# Ground Floor Plan

S4.55 COMPARISON

# Level 02 - Typical Podium Units

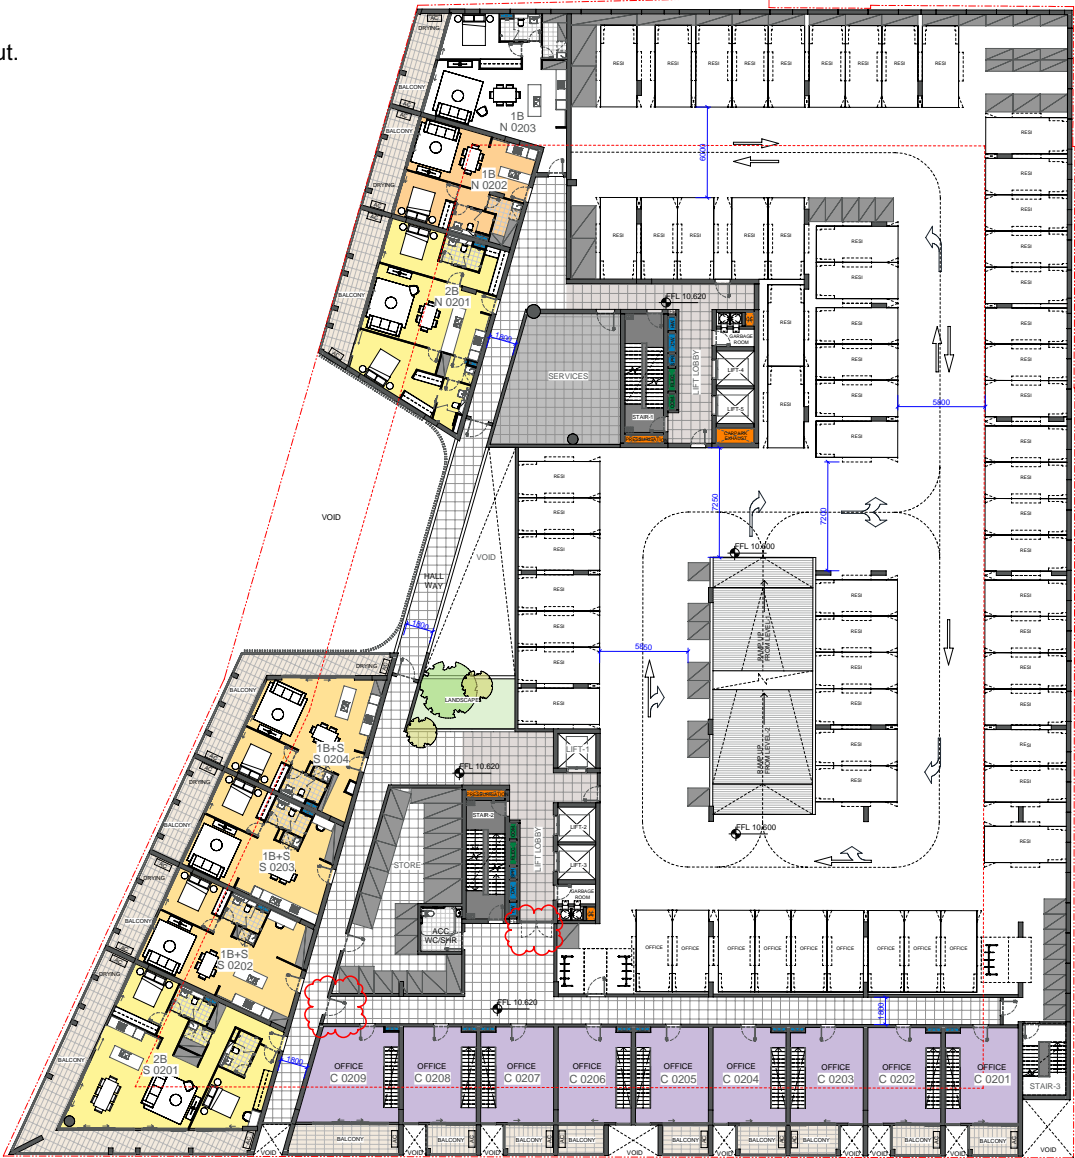
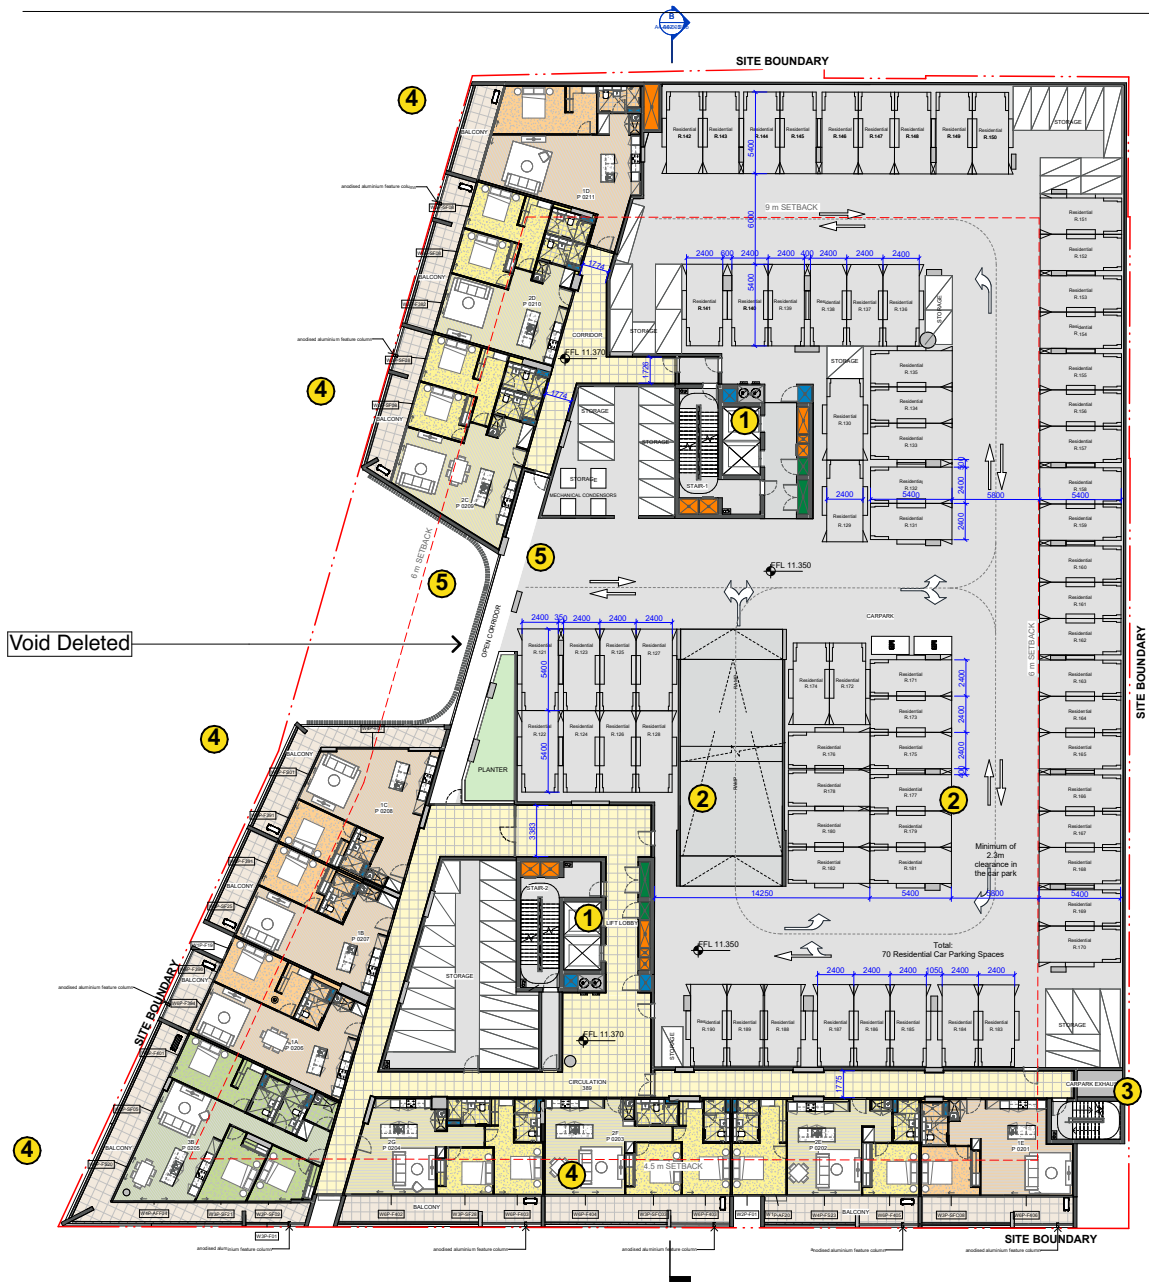
- 1. Lobbies changed:
  - a) Lift locations consolidated with stair following structural input.
  - b) South Tower only, ground to level 04 - 3 lifts changed to 2
  - c) Geometry of lobbies adjusted following detailed planning
- 2. Carpark rationalised to increase efficiencies:
  - a) Vehicle ramp moved to the West
  - b) Double stack carpark added
  - c) Bike storage replaced with storage allocated to units
- 3. Fire stair & carpark exhaust revised
- 4. Unit Planning changes
  - a) Minor planning changes to Units P0206-09, P0211
  - b) Unit P0210 changed from 1 bed to 2 bed
  - c) Upper level office spaces changed to 4 units
- 5. Changes near forecourt
  - a) Increase depth of forecourt
  - b) Commercial roof & void removed

## Level 03

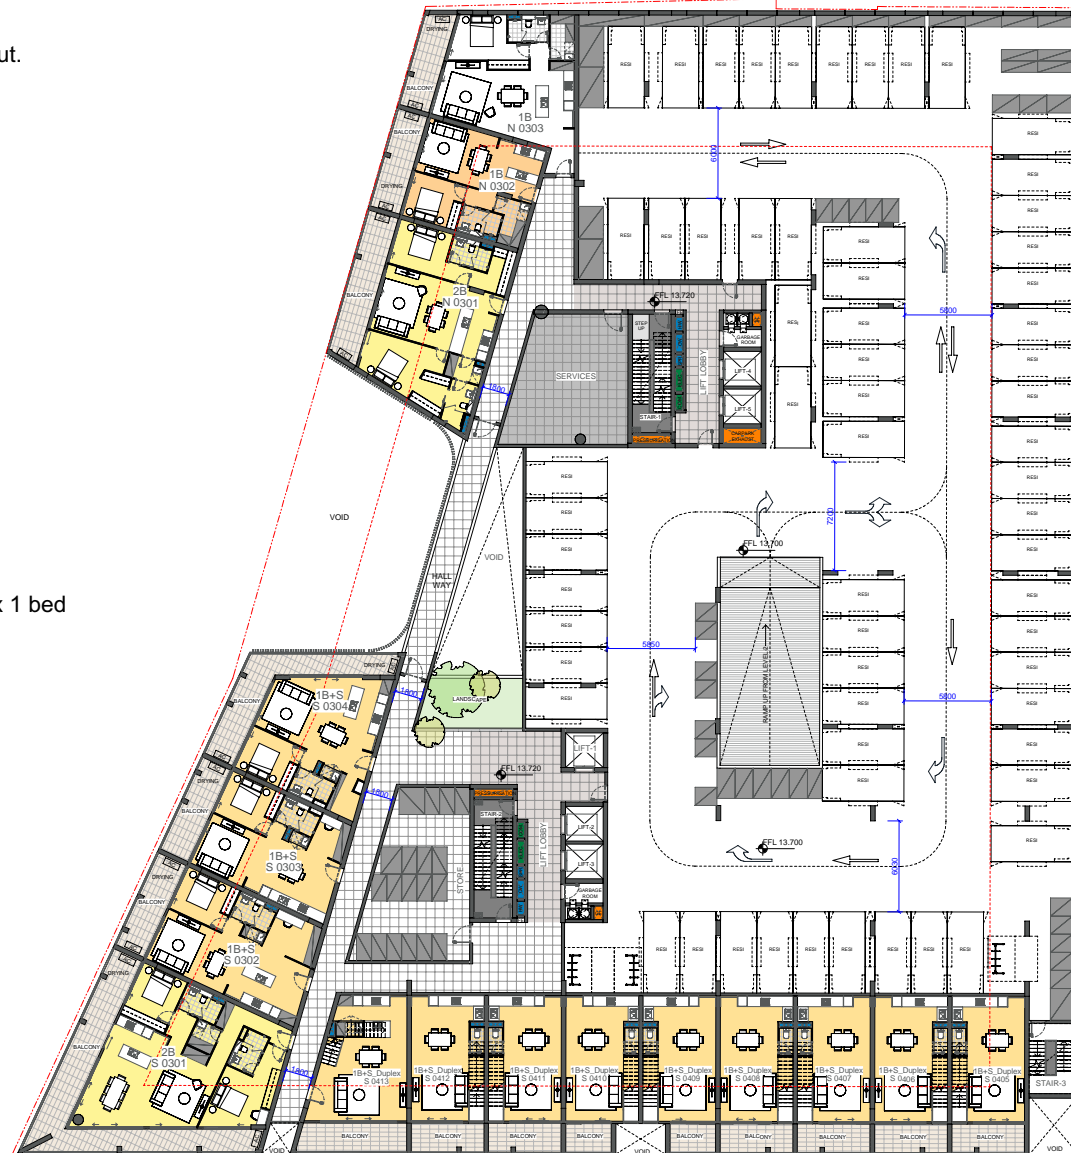
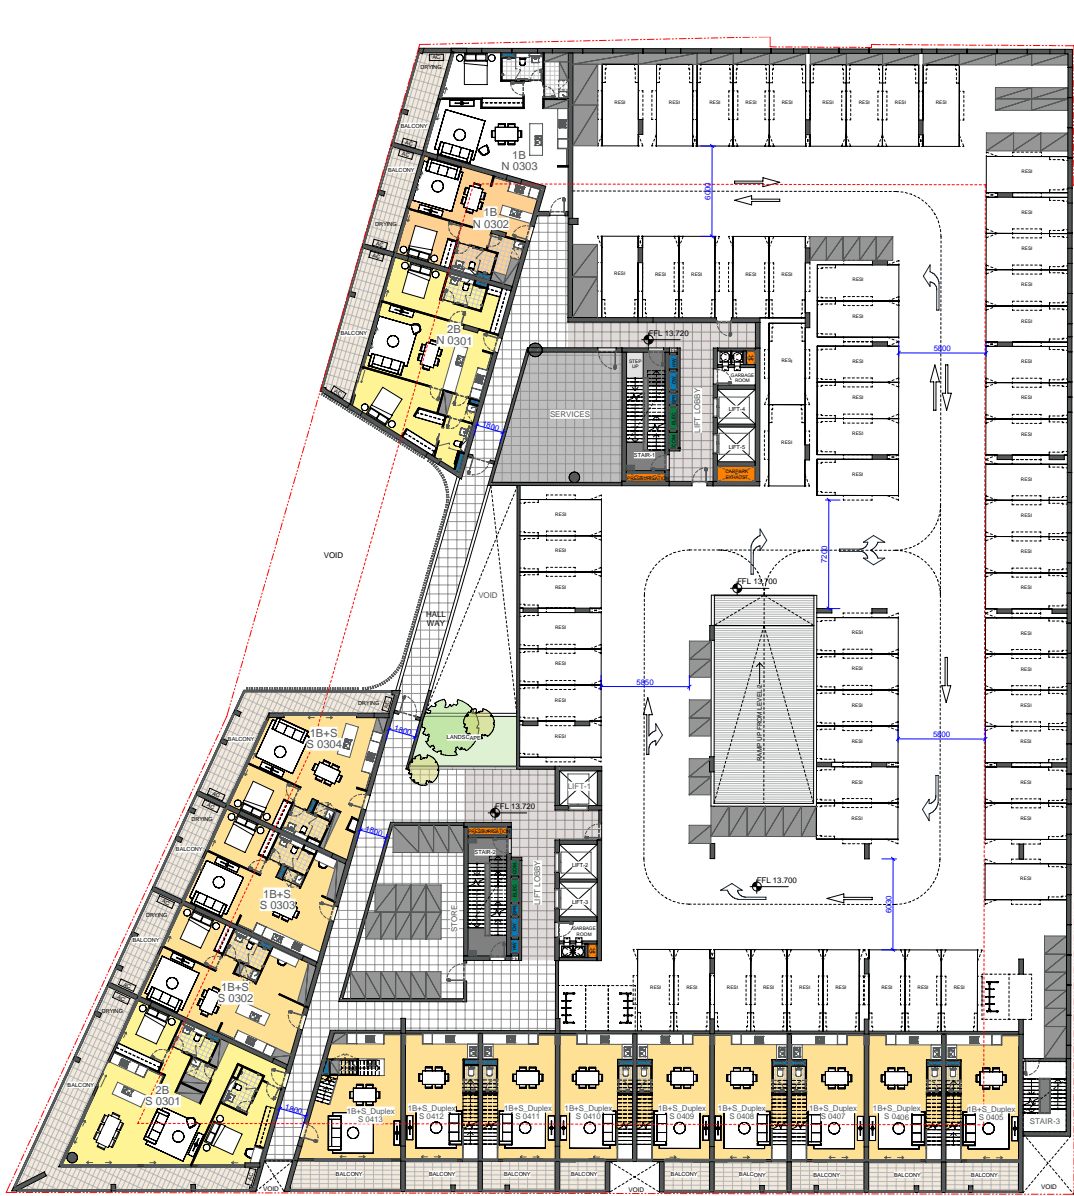
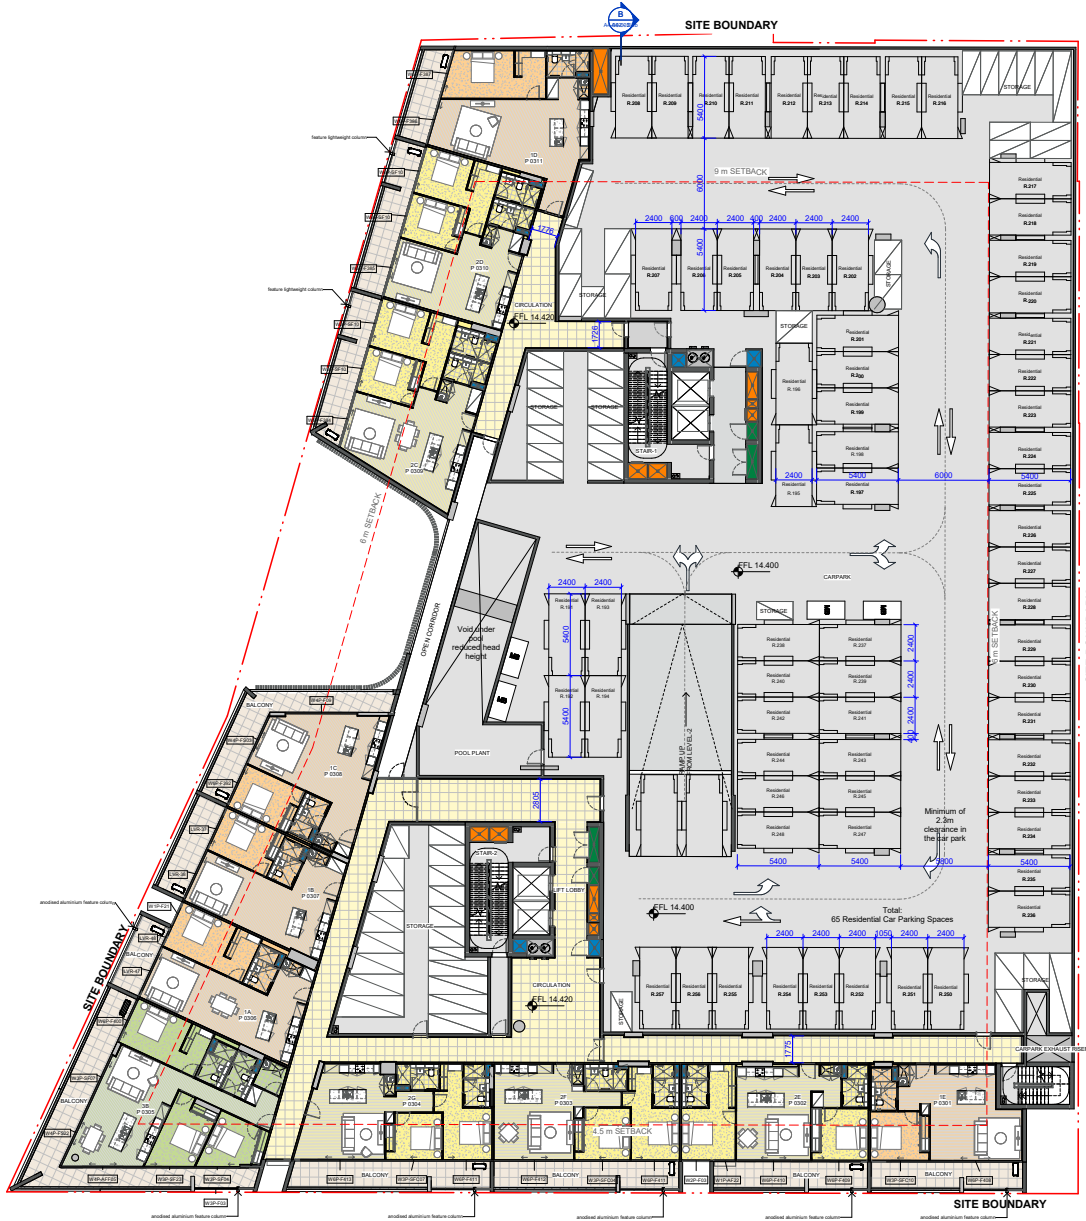
- 1. Lobbies changed:**
  - a)** Lift locations consolidated with stair following structural input.
  - b)** South Tower only, ground to level 04 - 3 lifts changed to 2

- c)** Geometry of lobbies adjusted following detailed planning
  - d)** Corridor added to South tower to access units
  - e)** Lobby adjusted to North tower

- 2. Carpark rationalised to increase efficiencies:**
  - a)** Vehicle ramp moved to the West
  - b)** Double stack carparks added
  - c)** Bike storage replaced with storage allocated to units

- d)** Motorbike spaces added
- 3. Fire stair & carpark exhaust revised**
- 4. Unit Planning changes**
  - a)** Minor planning changes to Units P0306-09, P0311

- b)** Unit P0310 changed from 1 bed to 2 bed
  - c)** 9 x 2 bed duplexes to the South changed to 3 x 2 bed, 1 x 1 bed
- 5. Changes near forecourt**
  - a)** Increase depth of forecourt

- b)** void removed, pool plant added
- 6. Services removed from carpark and replaced with storage open to carpark**

# Level 04 - Podium Top

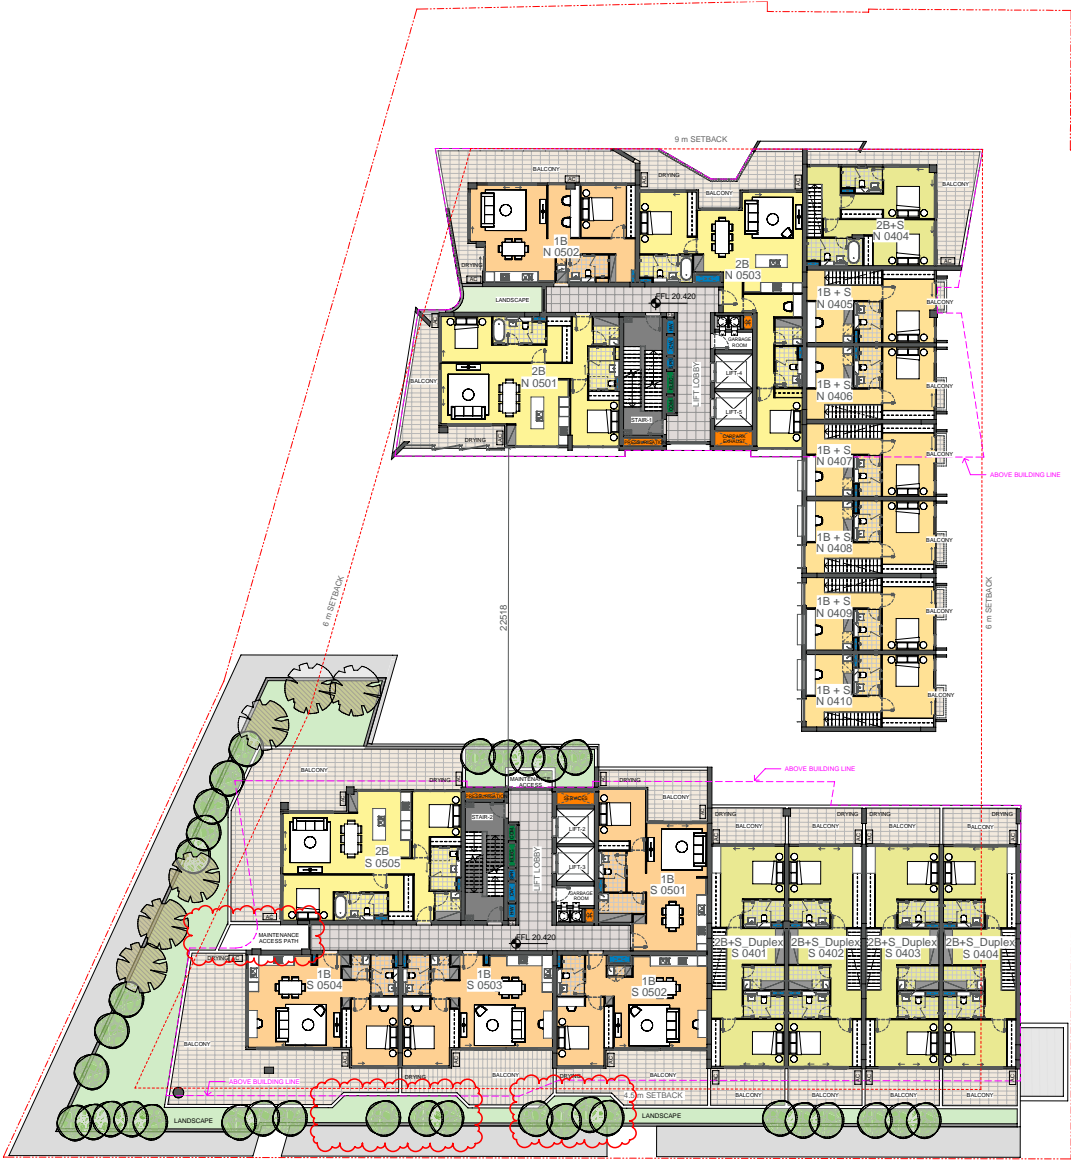
- 1. Lobbies changed:
  - a) Lift locations consolidated with stair following structural input.
  - b) South Tower only, ground to level 04 - 3 lifts changed to 2

- c) Geometry of lobbies adjusted following detailed planning
- 2. Communal Facilities enhanced:
  - a) Pool added to void
  - b) Cinema room added in lieu of library

- c) Recreation room moved to the location next to the pool
  - d) Minor adjustments to landscaping responding to new planning
  - e) Gym added with amenities and end of trip facilities

- 3. Fire stair & carpark exhaust revised
- 4. Unit Planning changes
  - a) Minor planning changes generally
  - b) Unit P0409 changed from 1 bed to 2 bed

- c) 9 x 2 bed duplexes to the South changed to 3 x 2 bed, 1 x 1 bed
  - d) Unit P0409 changed from 1 bed to 2 bed
- 5. Separation between North and South towers decreased

- a) minor decrease in landscaping and balcony
- 6. Balcony articulation revised
- 7. Apartments reconfigured:
  - a) Through link removed
  - b) number of duplexes to the east changed from 6 to 4, and 1 2 bed unit.

- 8. Landscape removed to provide maintenance access

# Level 05 Plan

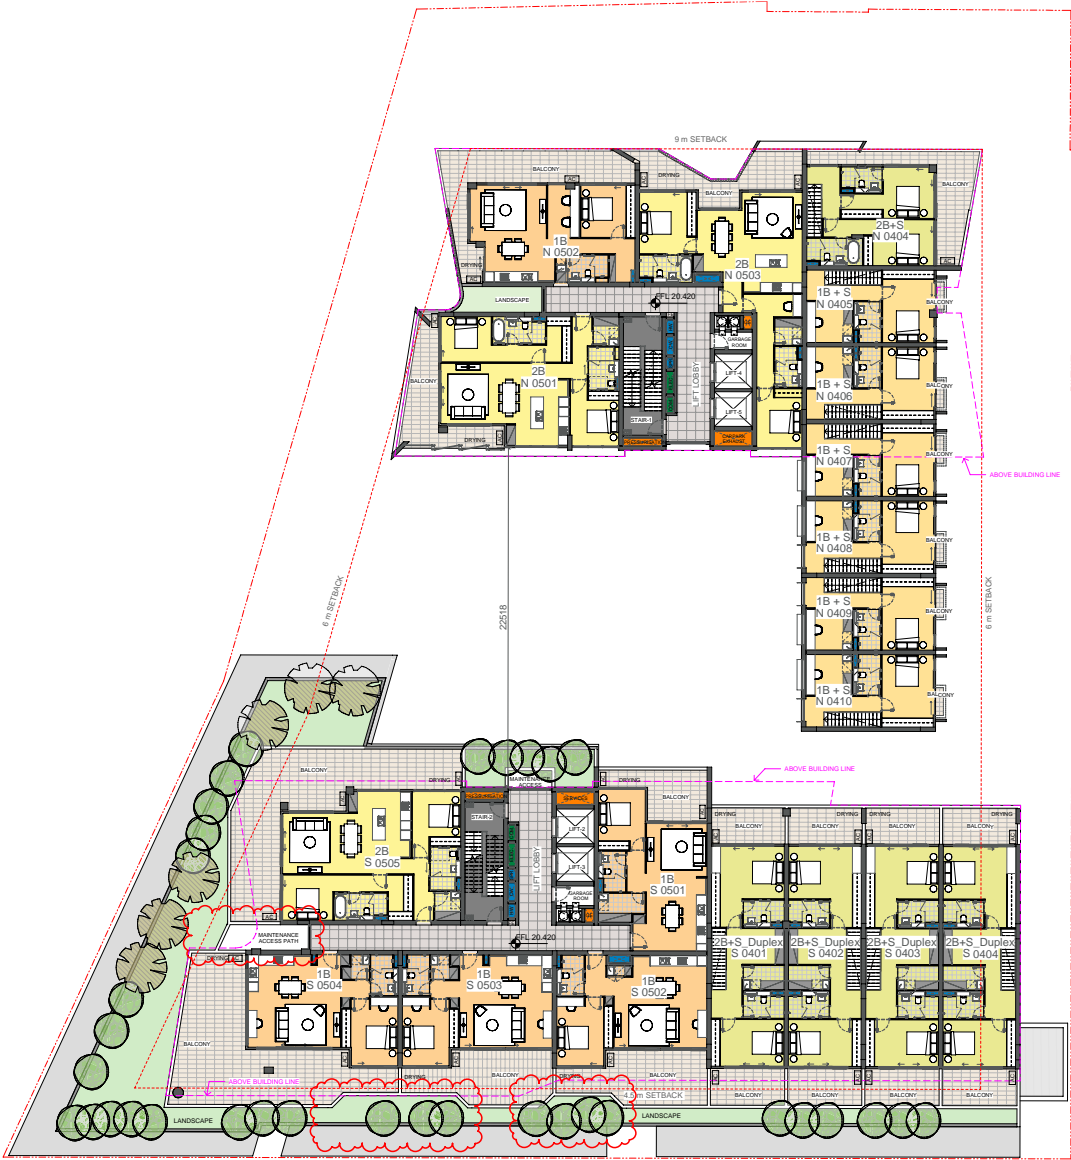
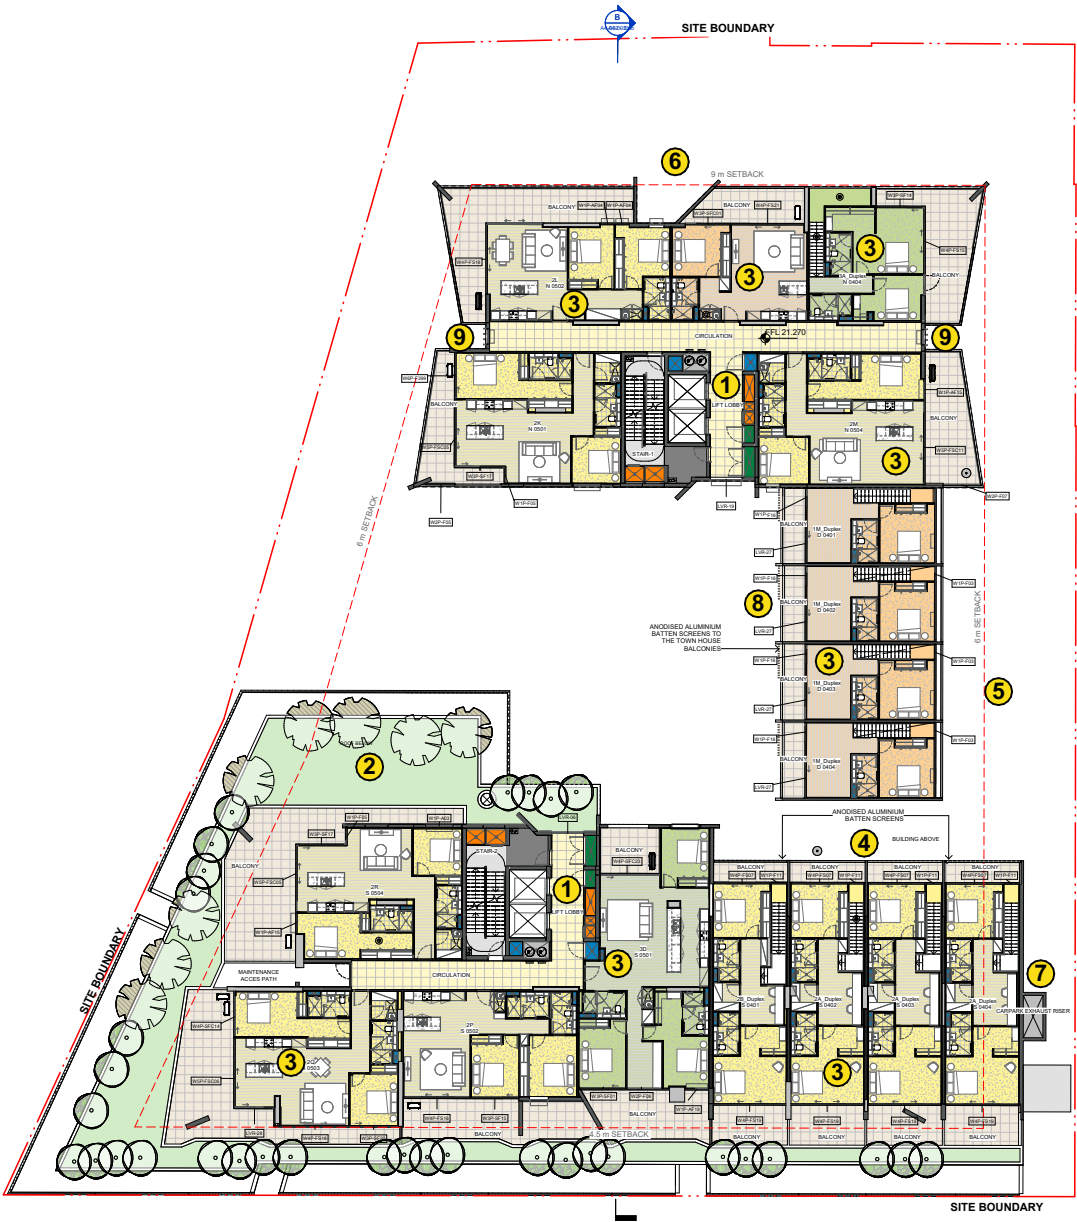
- 1. Lobbies changed - lift locations, consolidated with stair following structural input
- 2. Awning extended across unit S0504, landscaping increased
- 3. Minor alterations to unit layouts and circulation

- a) Units N0502 & N0503 changed from 1 bed to 2 bed
  - b) Unit N0404 external footprint adjusted
  - c) North tower units reconfigured & numbers reduced from 10 to 9 (1 duplex removed)

- d) South tower units reconfigured & numbers reduced from 9 to 8 (2 x 1 bed changed to 1 x 3 bed unit)
- 4. Separation between south tower and duplexes has decreased and balcony size to units S0401-S0404 decreased.

- Anodised aluminium screens added
- 5. Setbacks to boundaries remains the same
- 6. Minor alterations to tower geometry and construction detail
- 7. Carpark exhaust has been relocated to southeast

- 8. Balconies added to duplex's as a privacy buffer
- 9. Vertical external screens added
